# SERVICE BULLETIN

M-1098

## XL GEARCASE GASKETS

Figure 1. 2000 Cam cover and gasket

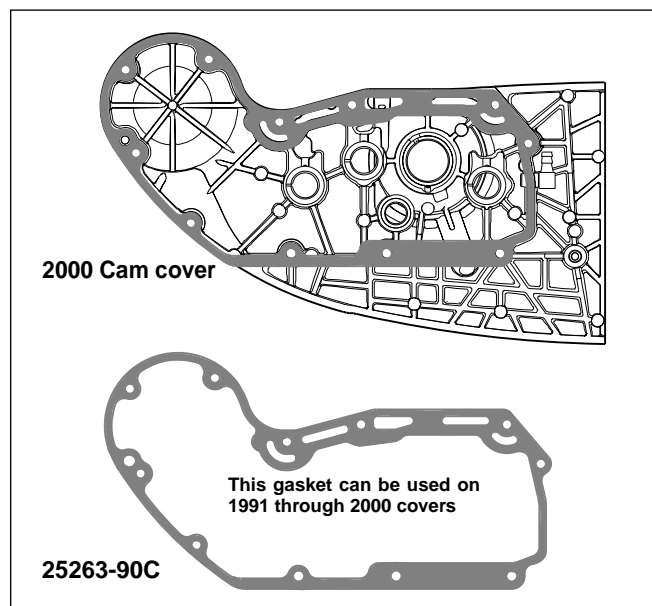
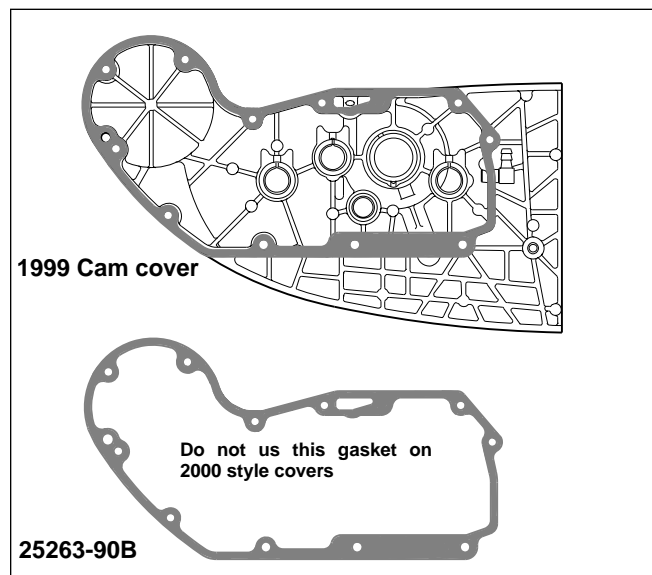
Late production 1999 Sportster and Buell engines use the model year 2000 gearcase cover and gasket. If the cover is removed and re-installed, care must be taken to install the correct gasket, or oil starvation can occur. The 2000 gasket (25263-90C) **MUST** be used with the 2000 style gearcase cover.

If a 25263-90B gasket is installed on a 2000 style gearcase cover, oil starvation can occur to the top end. Oil starvation can result in engine damage.

Model Year 1999 XL Motorcycles with engine numbers XX99-158-XXX to XX99-176-XXX have the 2000 cam cover and must use 25263-90C.

*The 2000 gasket (25263-90C) can retrofit cam covers to 1991.*

*The XL engine gasket kit 17026-91B has superseded to 17026-91C. The 17026-91C gasket kit contains the 25263-90C cam cover gasket.*
